BULLETIN: CA-SB-19-D-66-31
DATE: 7/7/66
PAGE: 1 OF 3

SERVICE BULLETIN

SUBJECT: FLOAT CHAMBER EQUALIZING VALVE AND
CHAMBER VENT; 19D11, 21, 31

Fig. 1
Equalizing
Valve
Arrangement

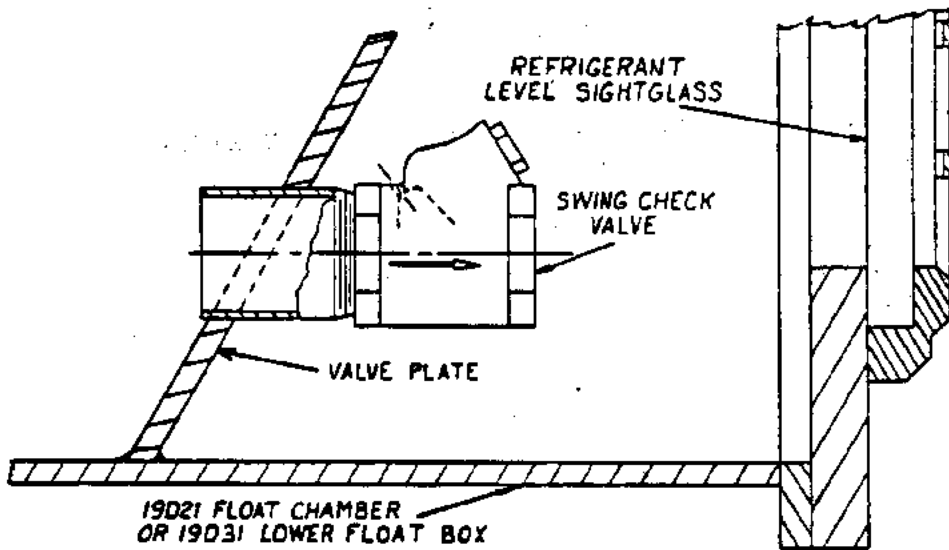
- A. Equalizing Valve. Machines shipped after March 1, 1965 (approximate unishell Serial No. 25780 and higher) have a newly designed equalizing valve in the float chambers (Fig. 1.) When exposed to refrigerant, the earlier neoprene design could possibly curl, keeping the valve partially open during machine operation.

Use check valve assembly 19U21-853 on 19D21 and 19D31 machines as a field replacement for the neoprene equalizing valve (Fig. 2) whenever the machine is opened for any reason. Drilling and tapping is not required. Use the existing 1/4-20 and 1/2-13 holes to bolt on the check valve and plate assembly.

On 19D11 machines only, the equalizing valve is not required and can be removed by tapping and plugging the three 1/2" drilled-through holes. (Use pipe tap size 3/8-18.) 19D11 unishells manufactured after approximately March 1, 1965, do not include an equalizing valve.
